OAK CONTRACTING LLC
Builders

ADDENDUM NO. 2

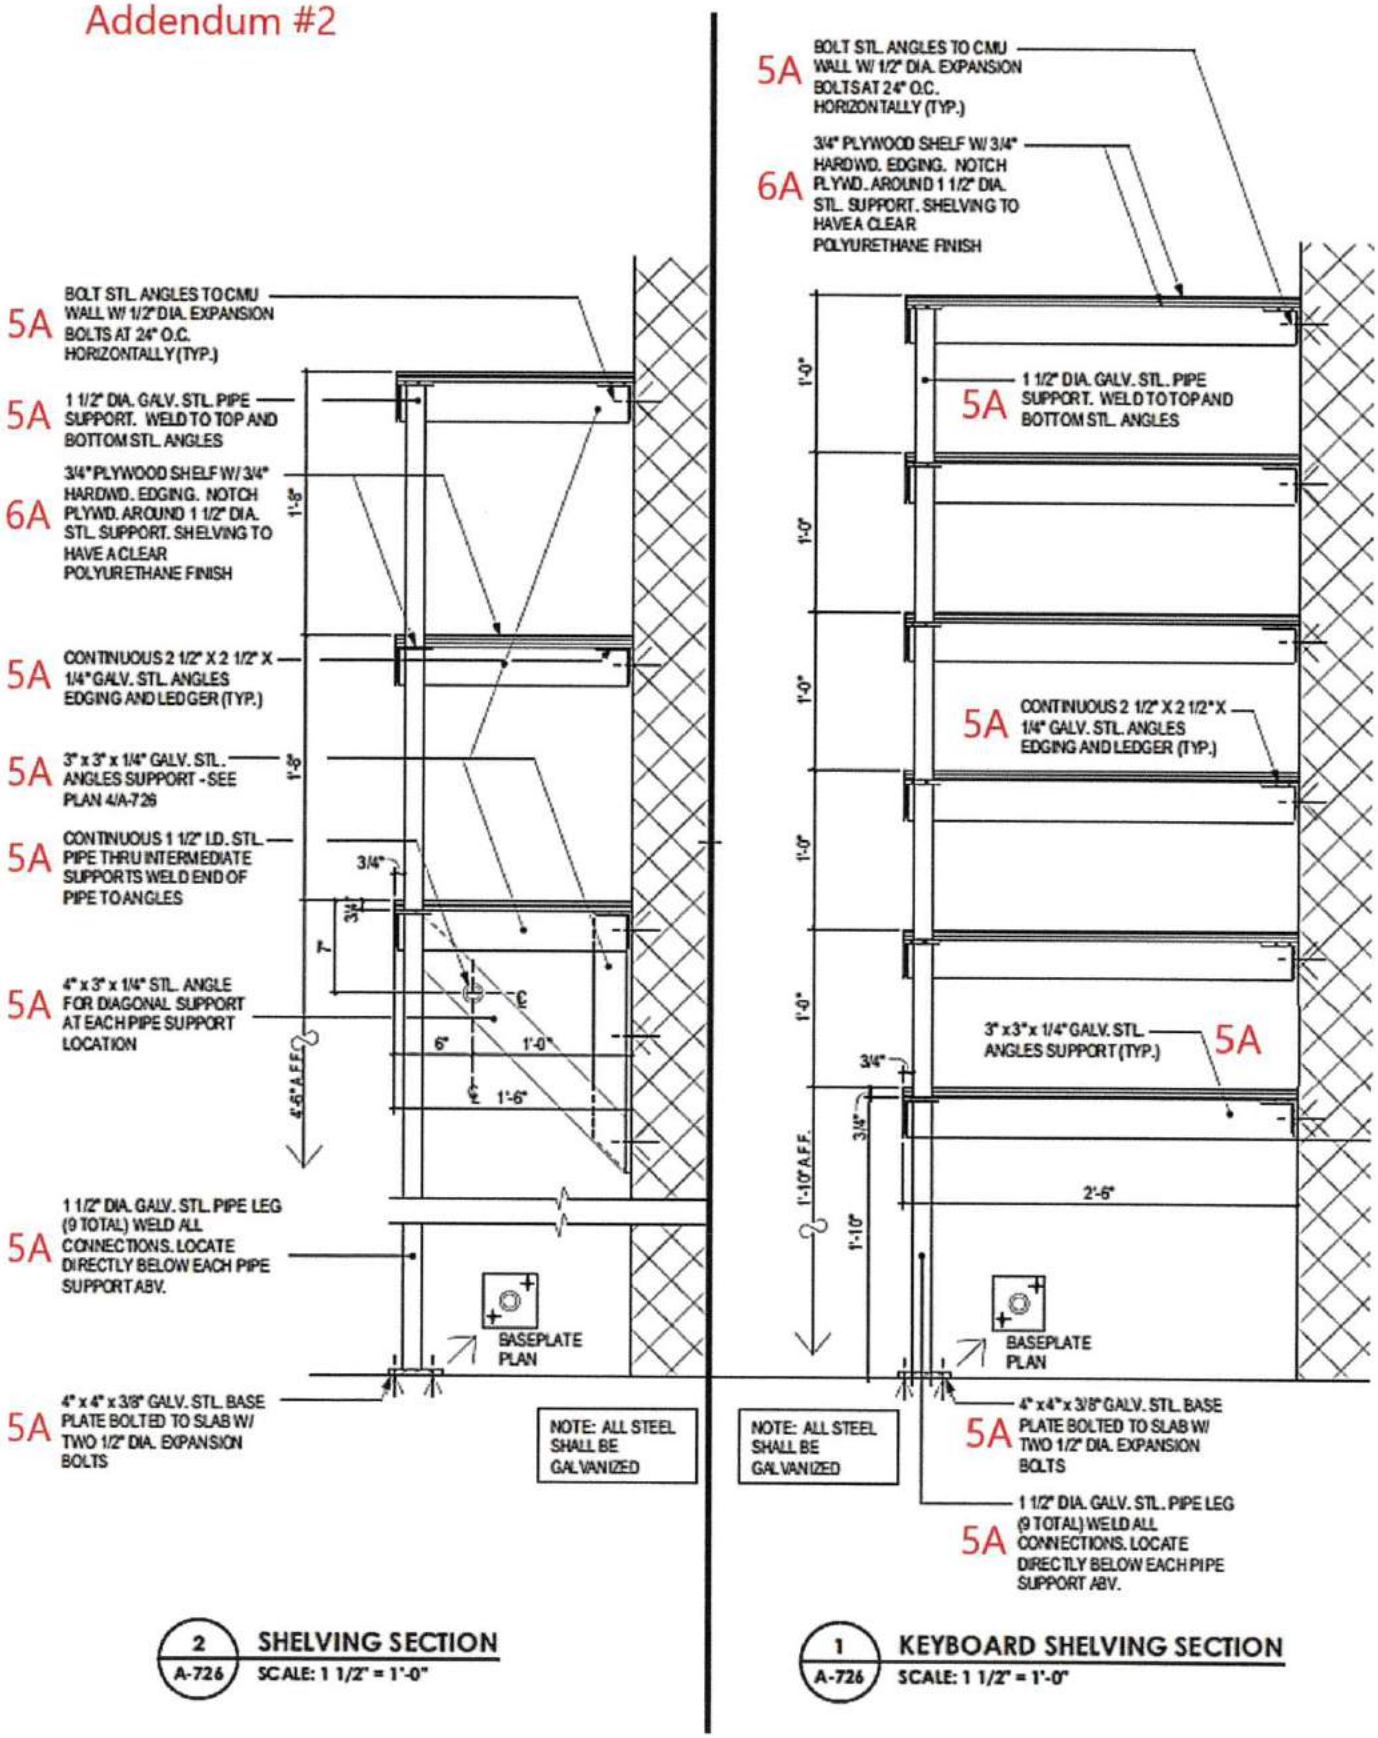
Scope Clarification Detail #20

Addendum #2

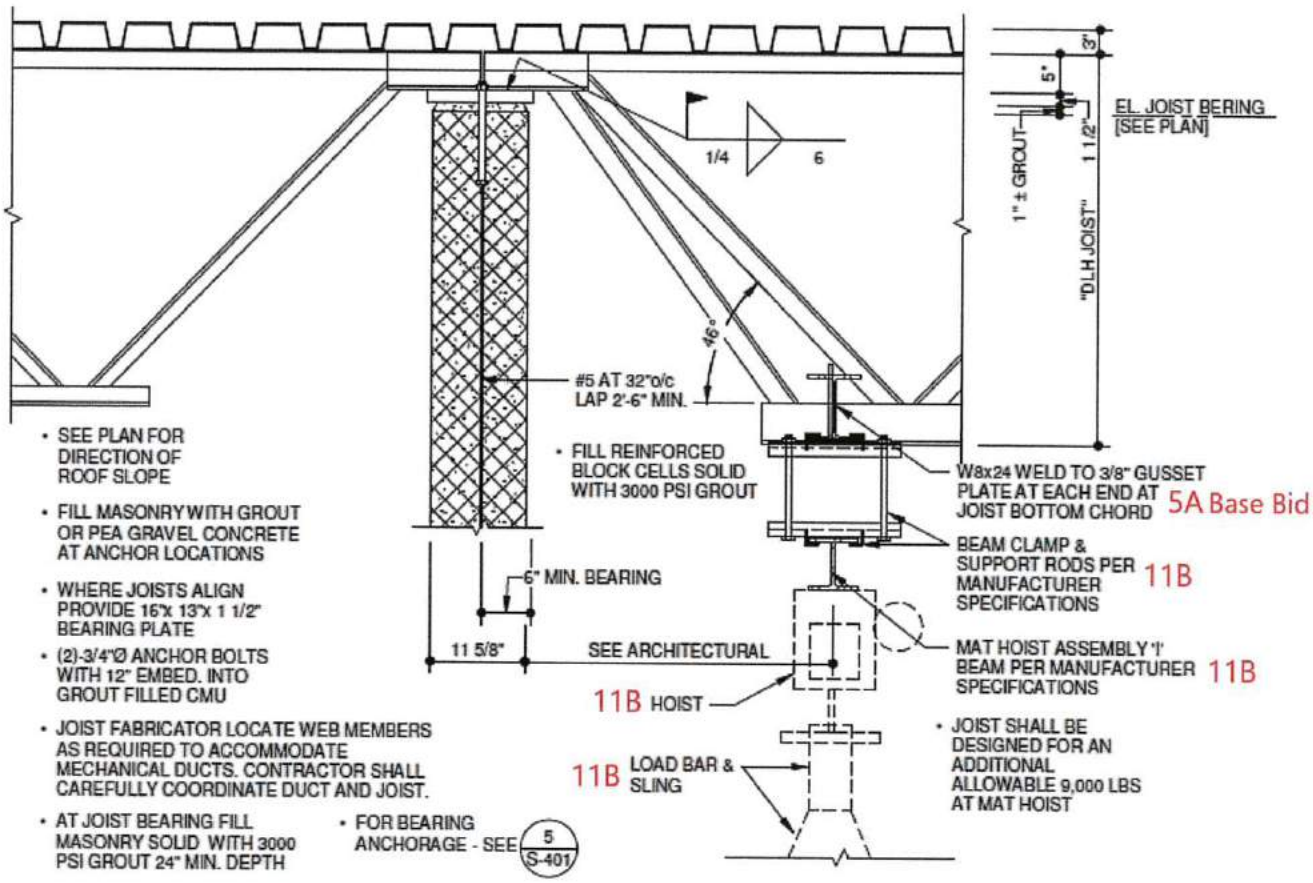
Scope Clarification Detail #21

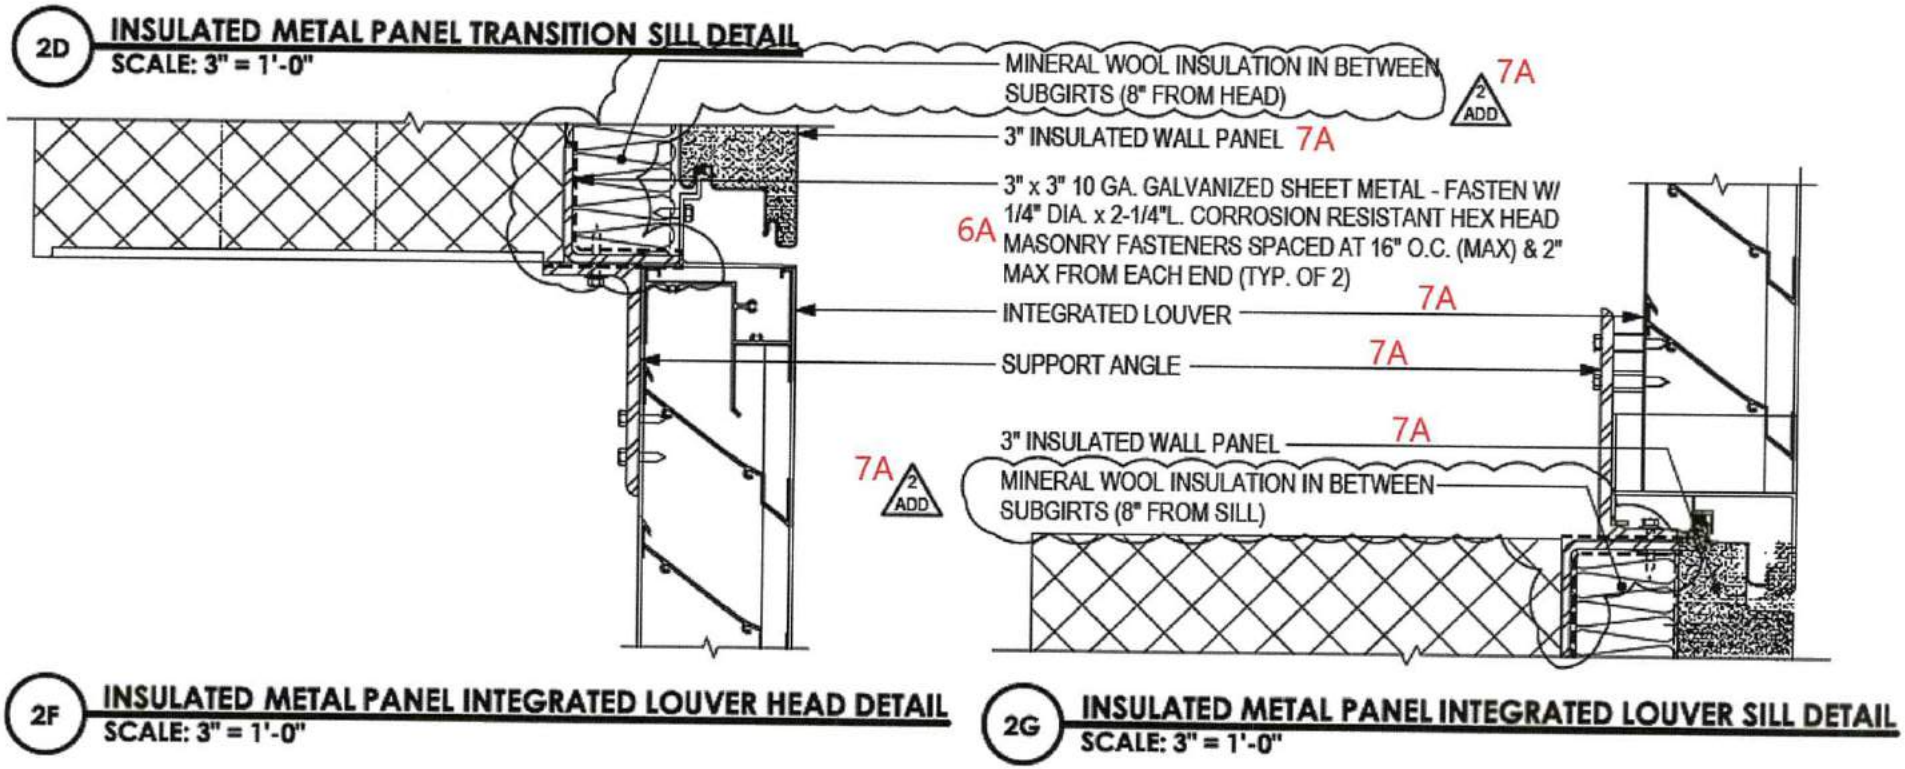
Scope Clarification Detail #23

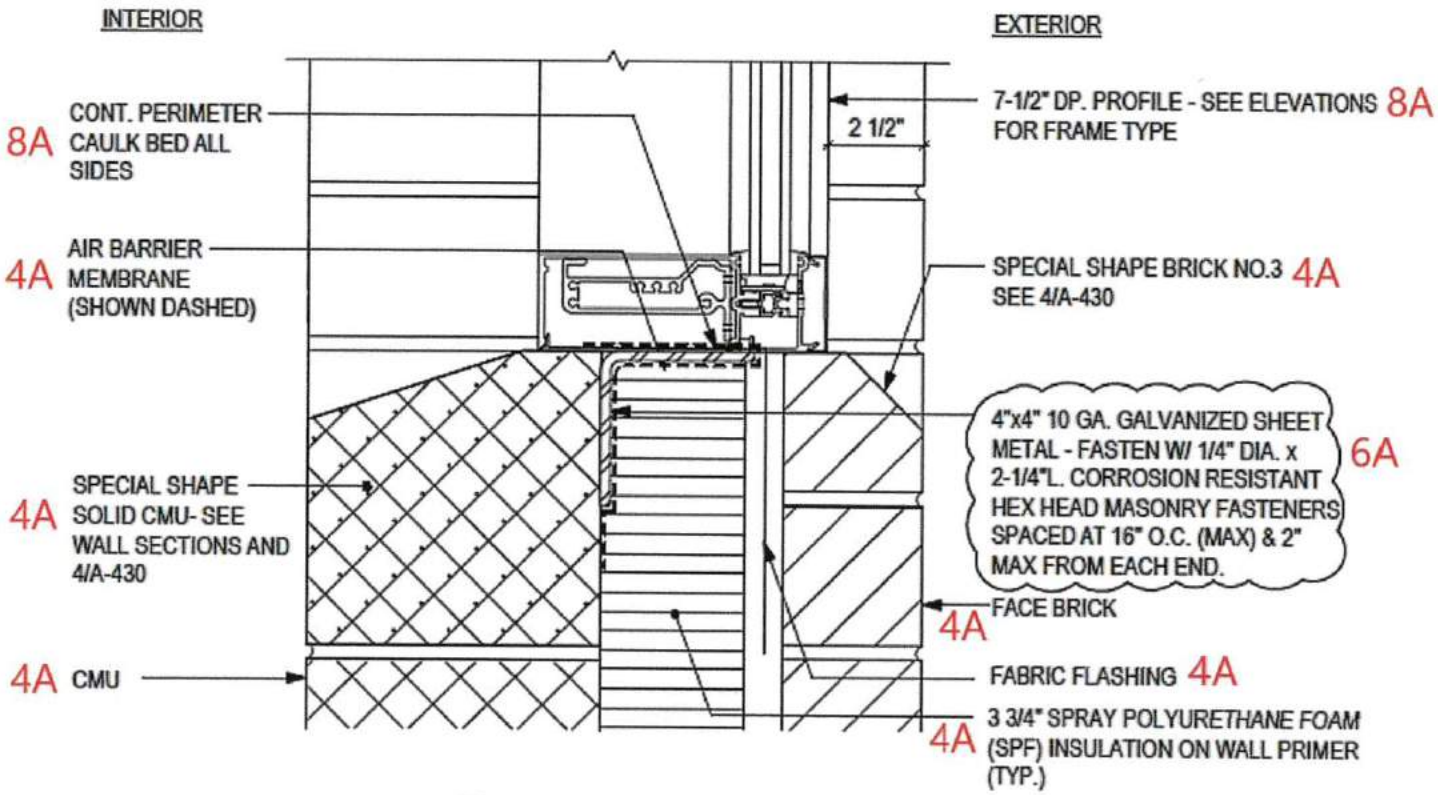
Scope Clarification Detail #24
